Westinghouse
Electric Corporation

Subject: Transmittal of Additional Information to Support the
Amendment Application to Expand Facility, License
SNM-1107, Docket 70-1151

ENCLOSURES TO TRANSMITTAL OF JUNE 12, 1979
LICENSE SNM-1107, DOCKET 70-1151

FIGURE 1.3.2.1

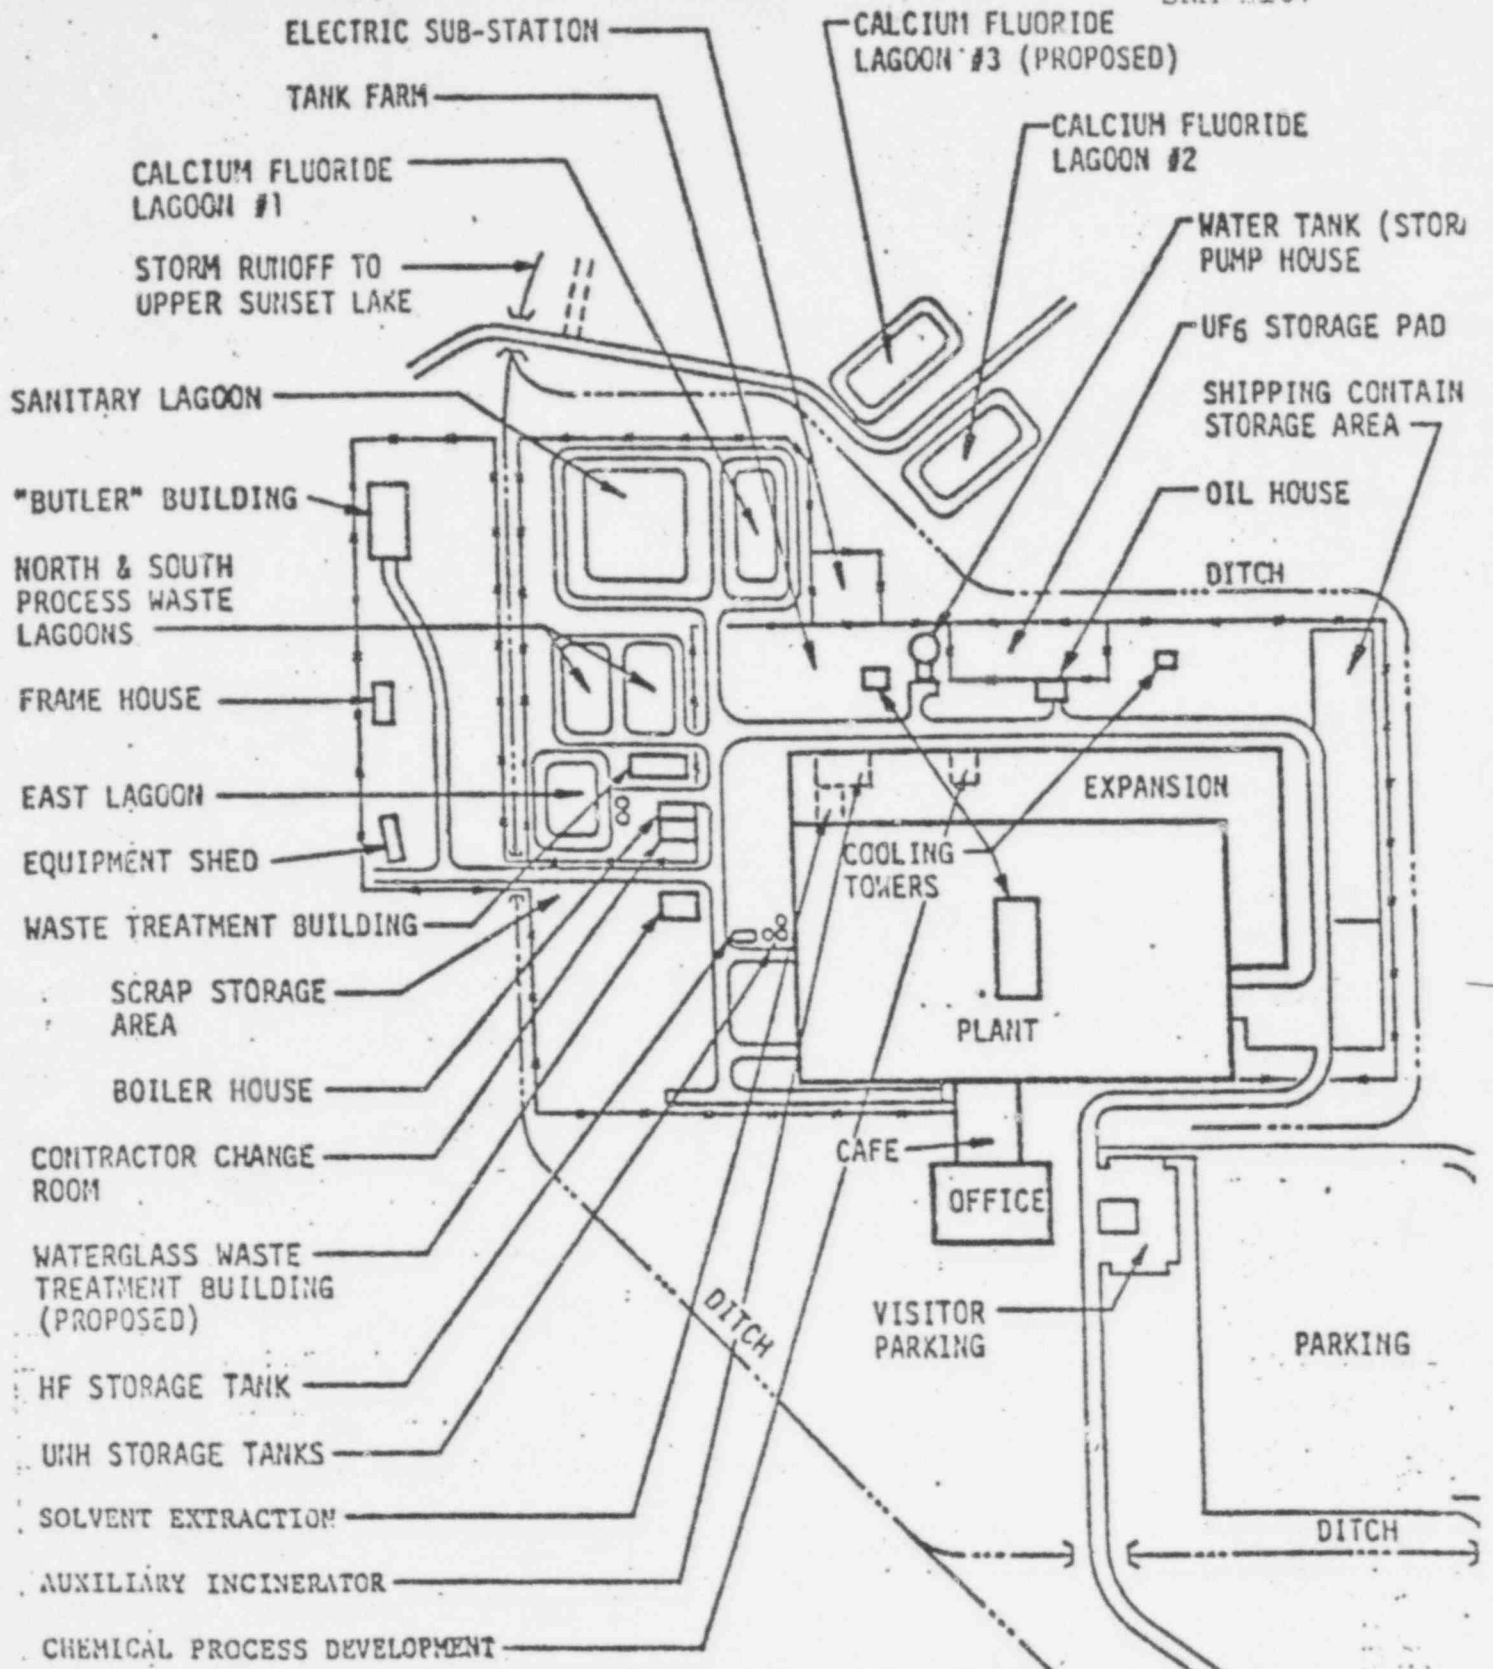
Page 18 - The date and revision number appear to be incorrect.

Please provide a plot plan, similar to Figure 3.1-1 of the Westinghouse Environmental Report, showing the area of the proposed expansion in relation to the existing plant, the new solvent extraction area, the chemical process development facility and the new incinerator system.

Attached is a changed page 18 with the correct revision number and date. Figure 1.3.2.1 was also modified to show the relative locations of the auxiliary incinerator, solvent extraction process and chemical process development within the plant expansion.

Figure 1.3.2.1 has been revised to show the relative locations of these processes.
